Access Compliance Report

Public Rights-of-Way

(Curb Ramps)

Intersection ID: 9296	Main Street: EDDLEMAN_RD	Cross Street: THOMASBORO_DR	Location: SW
ADA ID: 5B39F0DDFE62	Ramp Type: Perp	Initial Pass/Fail: Fail	Overall Compliance: No
Codes/Mitigation Info/Possible Solution		Field Measurements/Component Compliance	
Severity Score: 22.5

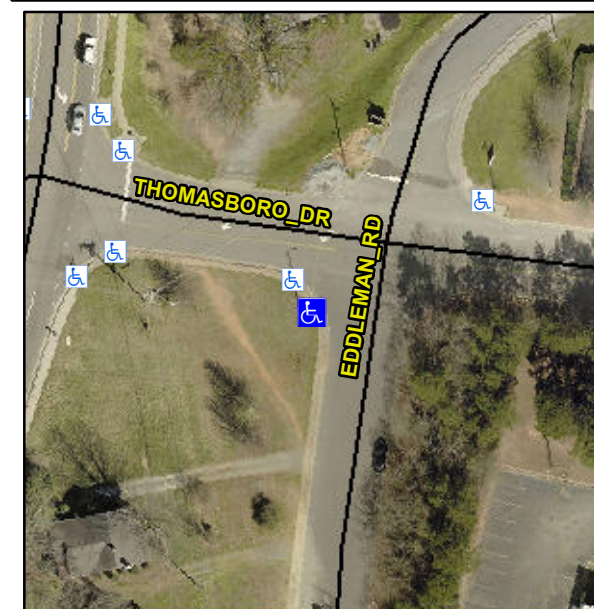
Not Found, R304.5.1, R304.2.2, R304.5.3

Compliance	Description	Data	Compliance	Description	Data
N/A	Ramp Length (in)	39.0	No	Ramp Slope (%)	11.2
No	Ramp Width (in)	37.0	No	Ramp XSlope (%)	4.5
N/A	Flare Type LT	N/A	N/A	Flare Type RT	N/A
N/A	Flare Slope LT (%)	N/A	N/A	Flare Slope RT (%)	N/A
N/A	Flare Traversable LT?	N/A	N/A	Flare Traversable RT?	N/A
N/A	Landing Length (in)	N/A	N/A	DWS Provided?	N/A
N/A	Landing Width (in)	N/A	N/A	DWS Contrast?	N/A
N/A	Landing Slope (%)	N/A	N/A	DWS Length (in)	N/A
N/A	Landing X Slope (%)	N/A	N/A	DWS Full Width?	N/A
N/A	Landing Curb? (Y/N)	N/A	N/A	DWS Offset (in)	N/A
N/A	Shared Landing?	N/A			
N/A	Gutter Ponding?	N/A	N/A	Gutter Slope (%)	N/A
N/A	Gutter Lip Ht (in)	N/A	N/A	Gutter X Slope (%)	N/A
N/A	Painted X Walk1?	No	N/A	Painted X Walk2?	N/A
	X Walk 1 Direction	To E		X Walk 2 Direction	N/A
N/A	X Walk 1 Width (in)	N/A	N/A	X Walk 2 Width (in)	N/A
	X Walk 1 Slope (%)	4.9		X Walk 2 Slope (%)	N/A
	X Walk 1 X Slope (%)	2.3		X Walk 2 X Slope (%)	N/A

Remove & Replace Entire Ramp.
